20th. February, 2003.

Further to my letter of the 12th. Inst. objecting to the granting of a licence to Indaver Ireland for a proposed Incinerator at Carranstown, Duleek, Co. Meath, I omitted the overlay map for the enclosed copy of the Hydrological Resource Protection zones for the area.

Figure 1 Monitoring Site Location for Ambient Air Survey at Carranstown

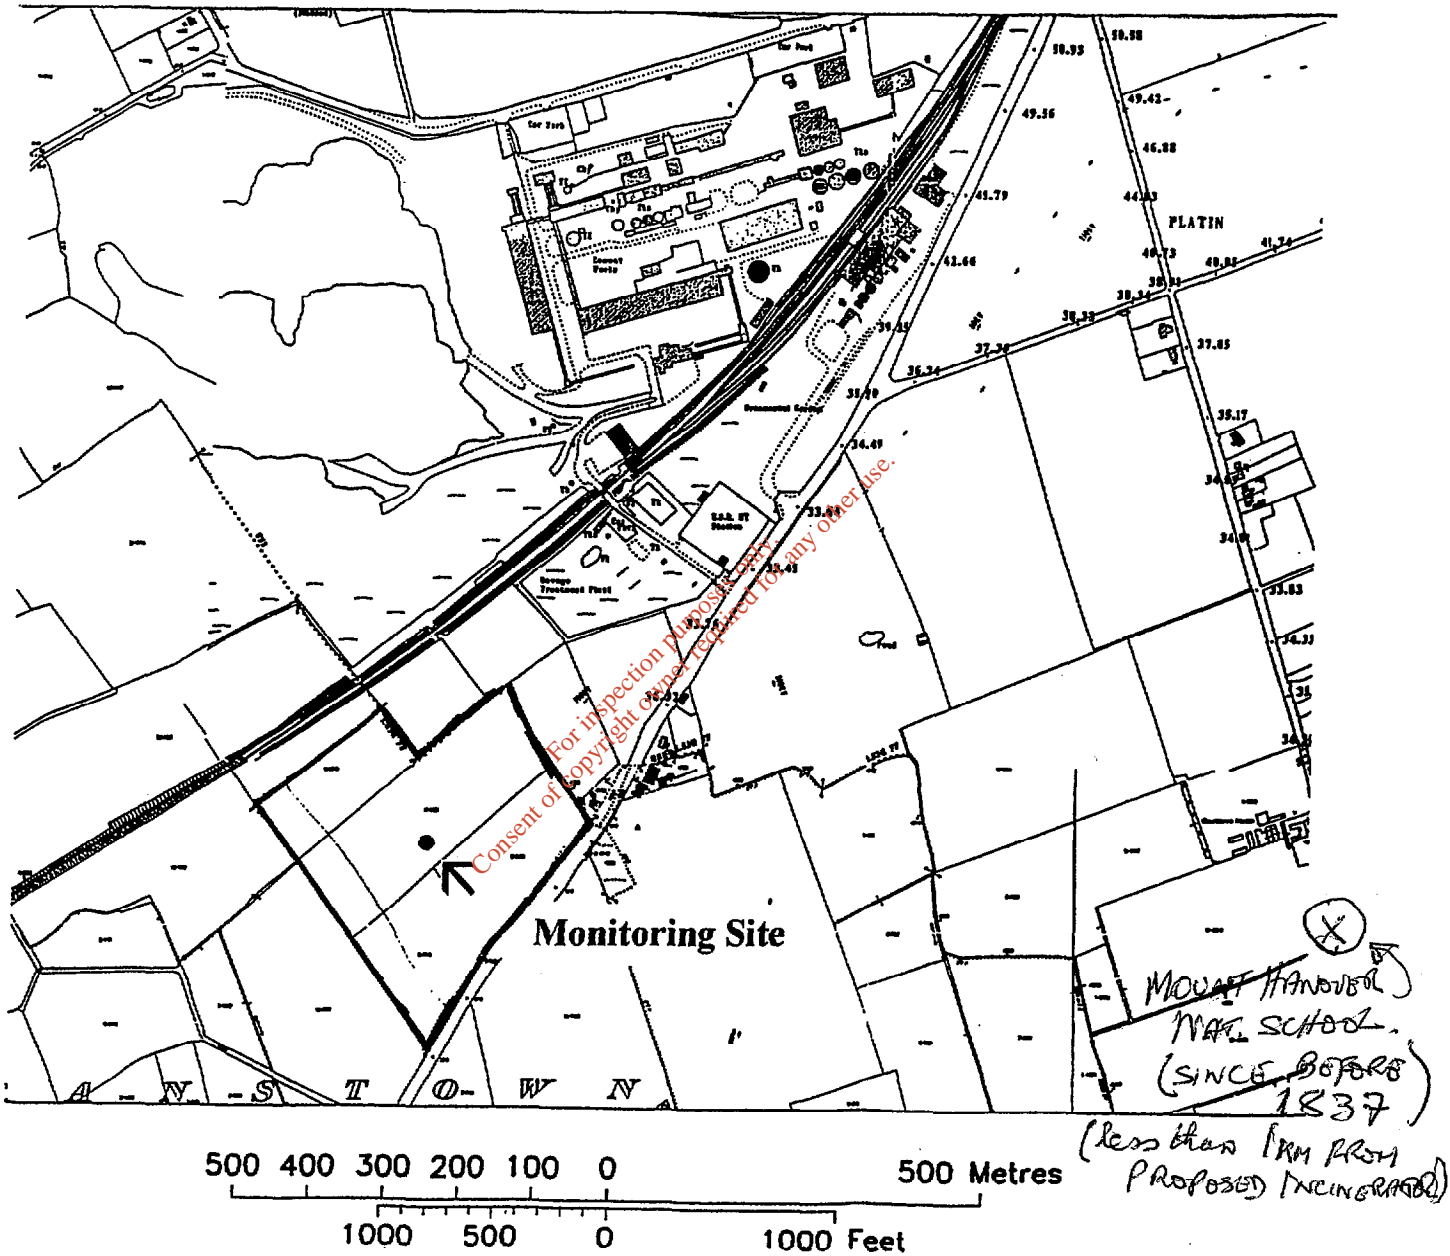
*Why is Mt. Hanover School
not clearly marked on
this map?*

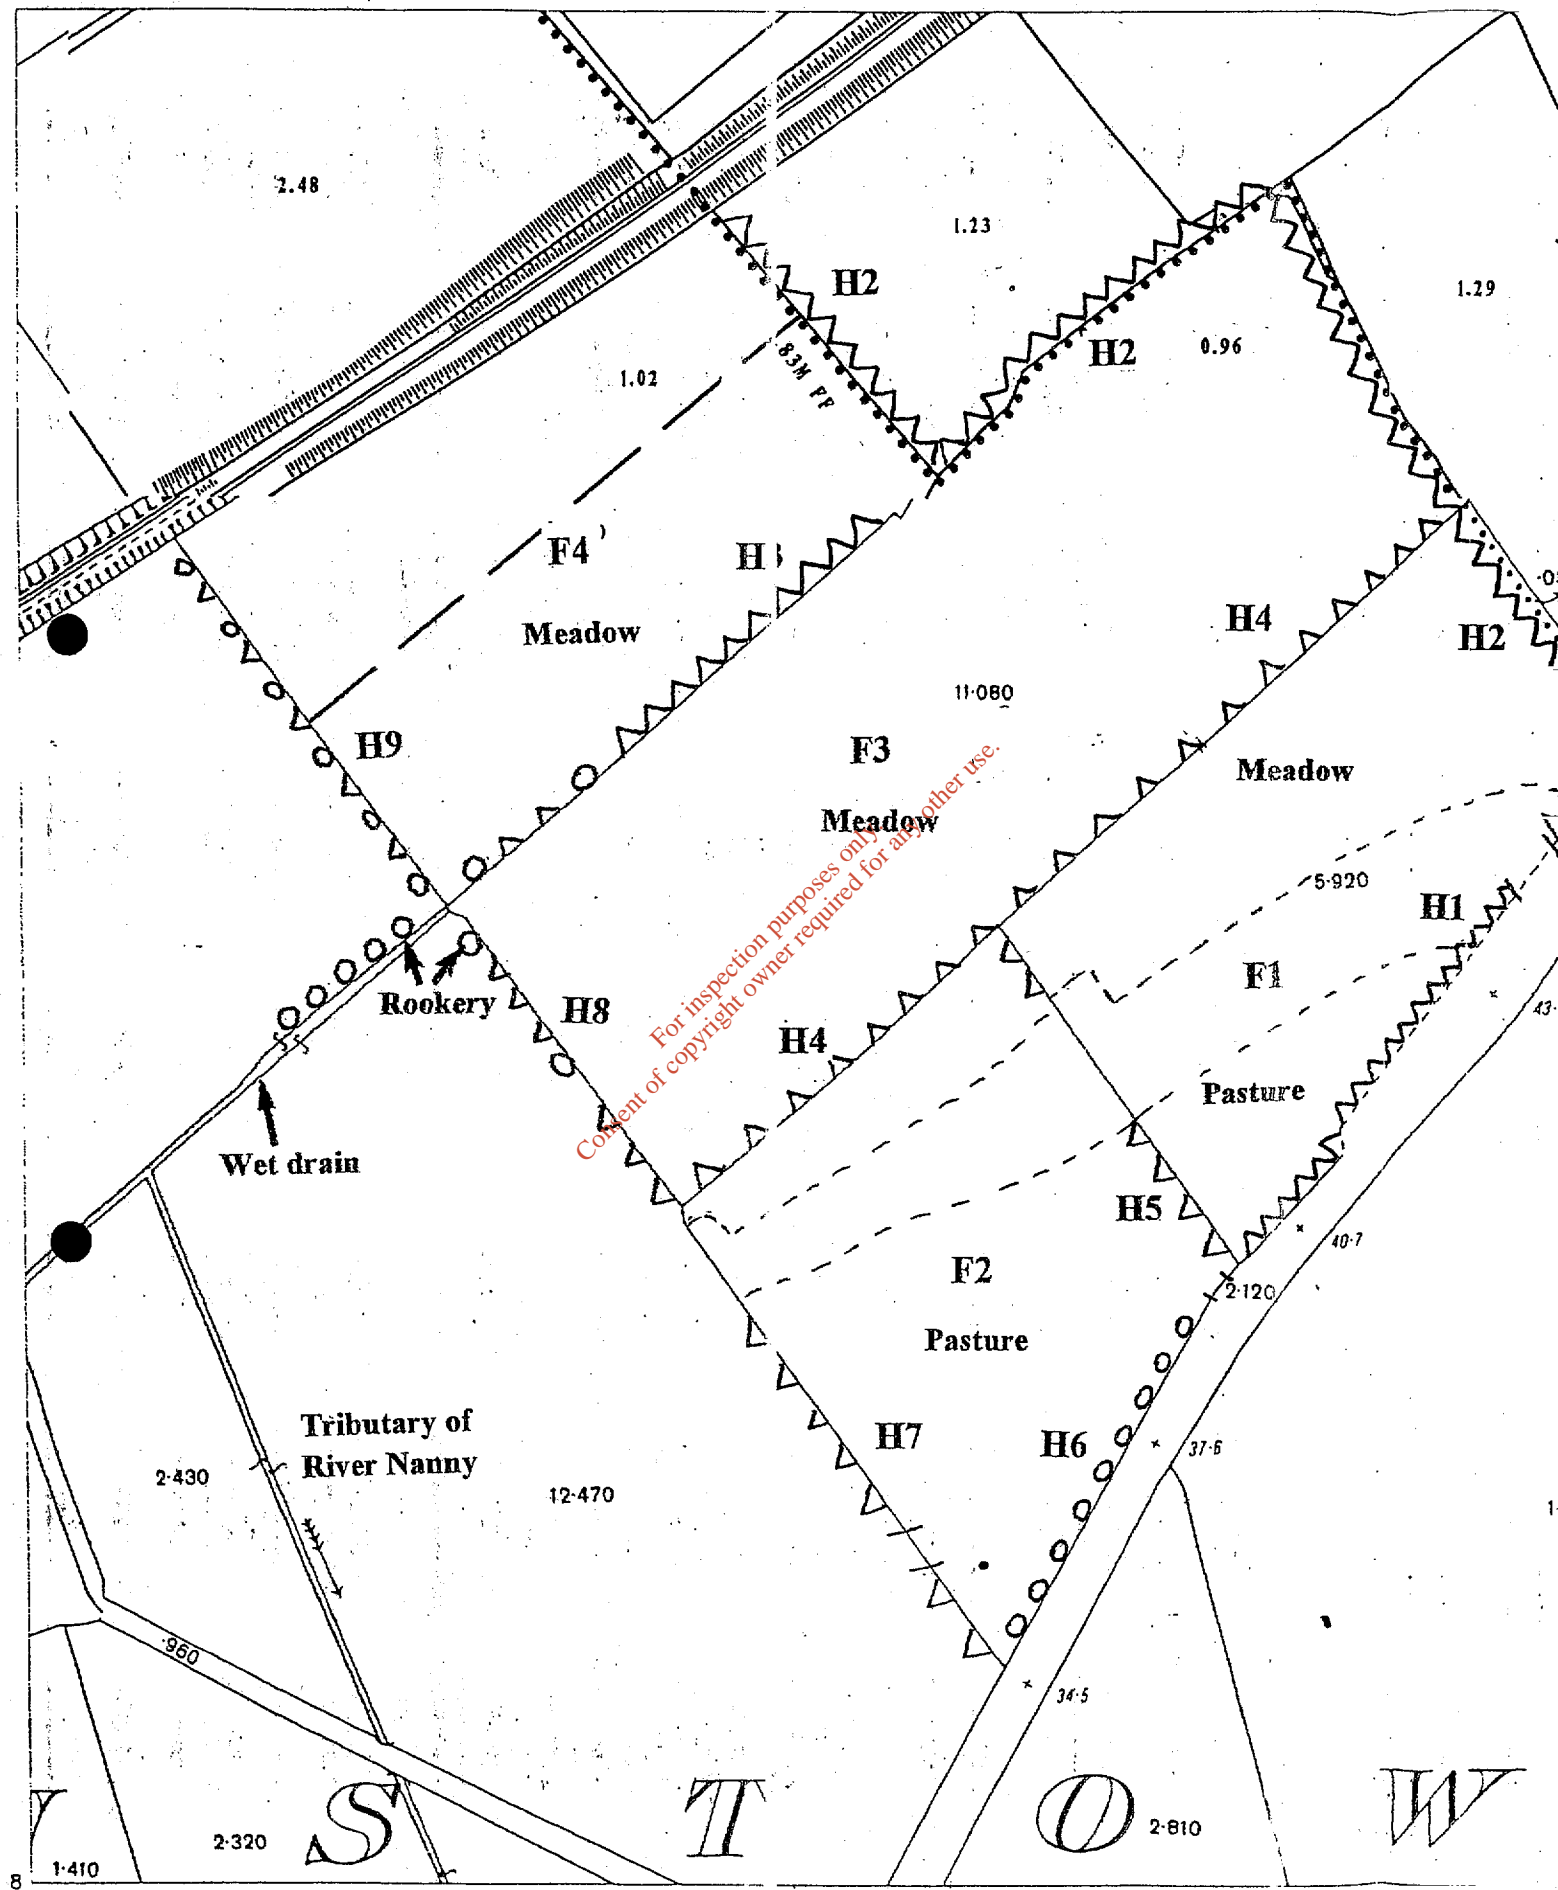
This is a copy of the overlay map
of the area - slightly enlarged - from
the G.S.I at Beggars Bush. This map
clearly shows Mt Henover School.
Why didn't the E.I.S for Indaver
do likewise?

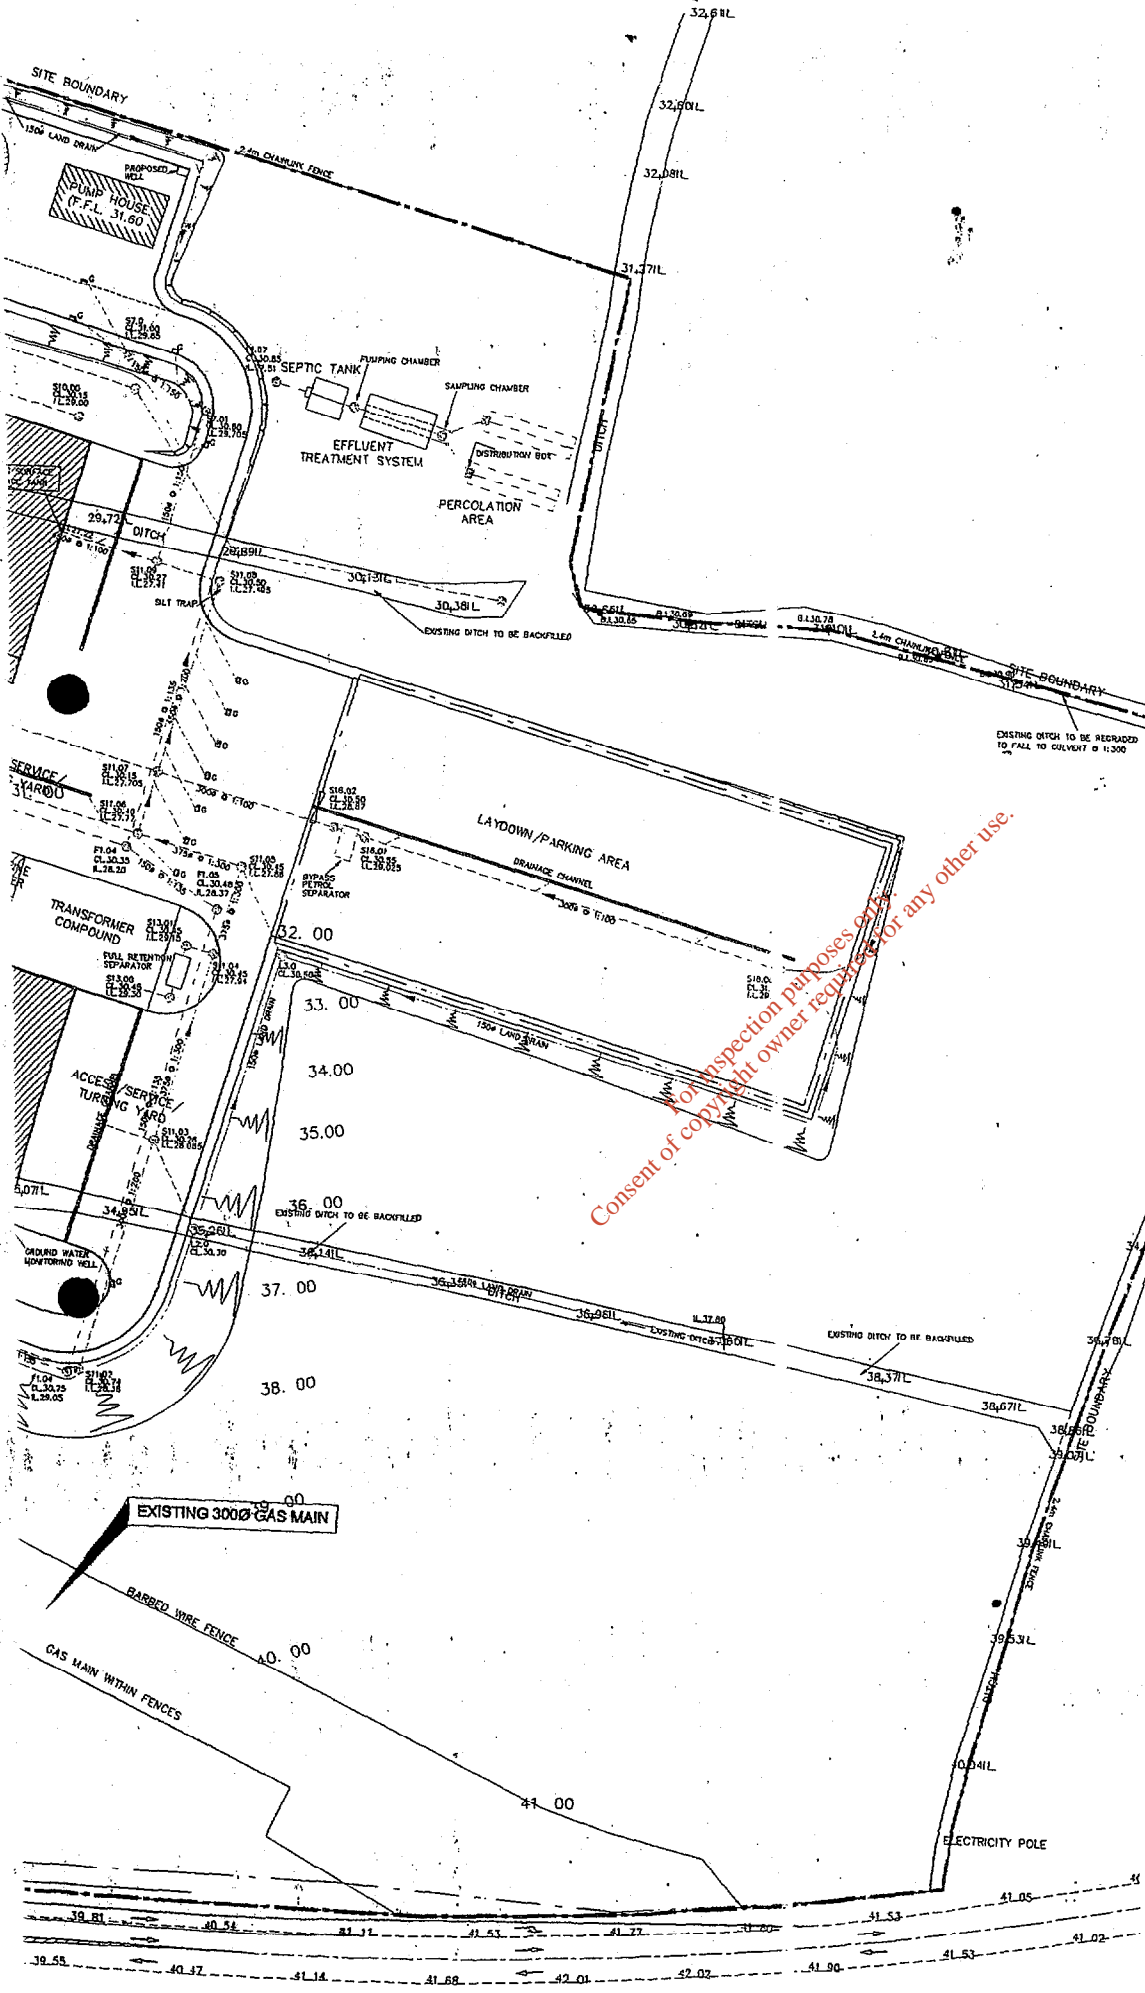
The spot heights of the "wet ditch" to the west of the site (which Indaver claimed was running Westward,) actually show that the flow is Eastward towards the site! Was this matter pursued at the time of the grant of permission? The most Westerly spot height is 28.94m and the other heights on the map moving East are, 28.75m, 28.63m, 28.58m, and 28.44m.

Furthermore there is a wet ditch (or Stream) contiguous with the site and running NORTHWARDS toward the area of EXTREME VULNERABILITY, where the spot heights shown are 31.05m (South most) to 30.98m, 30.66m, 30.34m, 29.68m, and 29.25m back to a "headwall at 29.24m. This headwall is within 30M of the zone of Extreme Vulnerability Rf/E. According to the "Co. Meath Groundwater Protection Scheme" (Oliver Perkins) this puts the proposed Incinerator in an R4 Zone, i.e. NOT ACCEPTABLE for potentially polluting activity!

This area is as you know, on the edge of the "Boyne Valley Bru Na Boinne" and is contiguous with the N.H.A. Duleek Commons, and has a gas main running through the site. What about the fire hazard in the event of an accident? From their own map of the proposed site it is obvious that the main surface water drain from the entire site runs into a point which is within 20M of the area of EXTREME VULNERABILITY! Rf/E.

Fig. 3 First edition Ordnance Survey map, Co.Meath, sheet 27a/1 & 12.
 Surveyed 1837 Scale 1:10,560

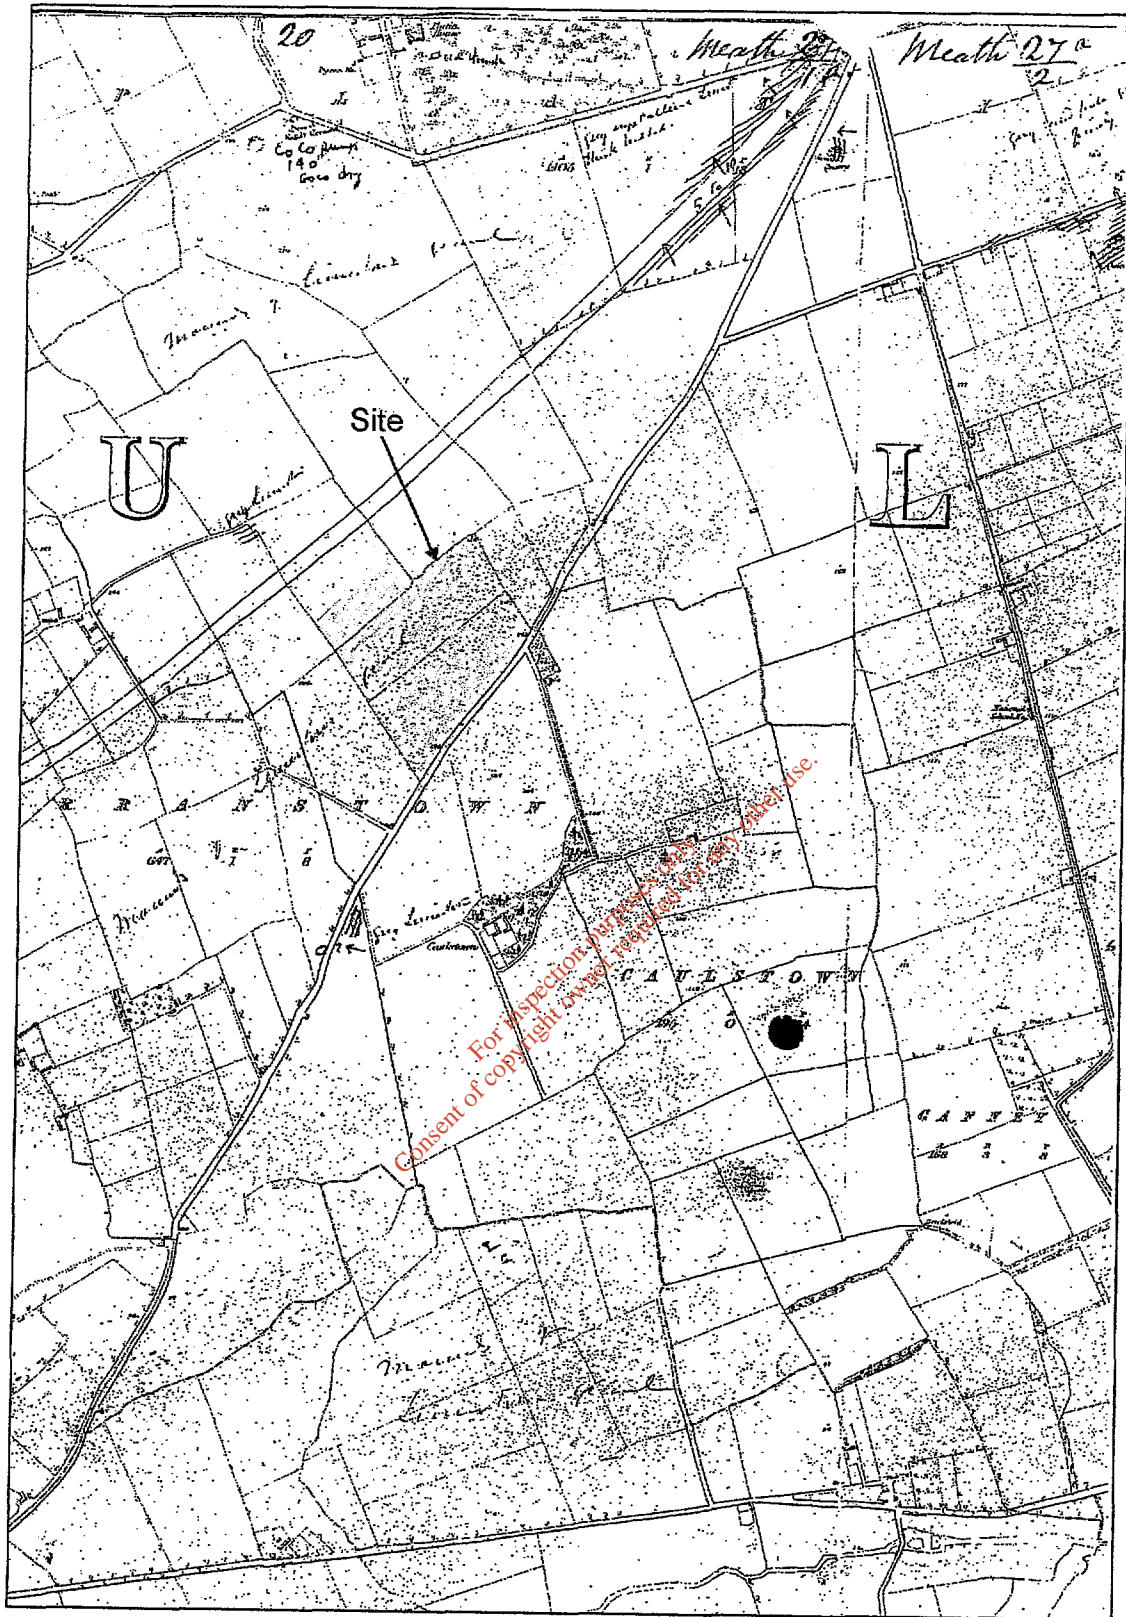
*Mt Hanover National School
 is marked on this 1837 map*
